Access Compliance Report Public Rights-of-Way (Curb Ramps)

Intersection ID: 3642 Main Street: PERIMETER_WOODS_DR **Cross Street: PERIMETER_PY** Location: SE **Severity Score:** ADA ID: 5F4A8E48C61B Ramp Type: Perp Initial Pass/Fail: Fail **Overall Compliance: No** 10

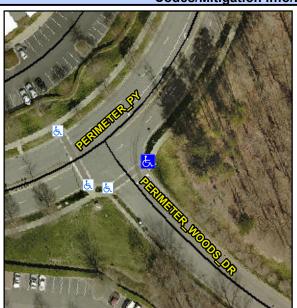
Possible Solutions: Remove & Replace Entire Ramp. Surveyor Notes: N/A PROW/ADA: Not Found, R304.5.1, R304.5.3

Comp	liance Description		mponent Compliance Compliance Description Data			
		Data 50.5				Data
N/A	Ramp Length (in)	59.5	Yes	•	Slope (%)	7.3
No	Ramp Width (in)	47.5	No		XSlope (%)	3.1
N/A	Flare Type LT	N/A	N/A		Type RT	N/A
N/A	Flare Slope LT (%)	N/A	N/A		Slope RT (%)	N/A
N/A	Flare Traversable LT?	N/A	N/A		Traversable RT?	N/A
N/A	Landing Length (in)	N/A	N/A		Provided?	N/A
N/A	Landing Width (in)	N/A	N/A		Contrast?	N/A
N/A	Landing Slope (%)	N/A	N/A		Length (in)	N/A
N/A	Landing X Slope (%)	N/A	N/A		Full Width?	N/A
N/A	Landing Curb? (Y/N)	N/A	N/A	DWS	Offset (in)	N/A
N/A	Shared Landing?	N/A				
N/A	Gutter Ponding?	N/A	N/A	Gutter	Slope (%)	N/A
N/A	Gutter Lip Ht (in)	N/A	N/A	Gutter	X Slope (%)	N/A
N/A	Painted X Walk1?	Yes	N/A	Painte	ed X Walk2?	N/A
	X Walk 1 Direction	To SW		X Wal	k 2 Direction	N/A
N/A	X Walk 1 Width (in)	71.0	N/A	X Wal	k 2 Width (in)	N/A
	X Walk 1 Slope (%)	2.2		X Wal	k 2 Slope (%)	N/A
	X Walk 1 X Slope (%)	3.5		X Wal	k 2 X Slope (%)	N/A
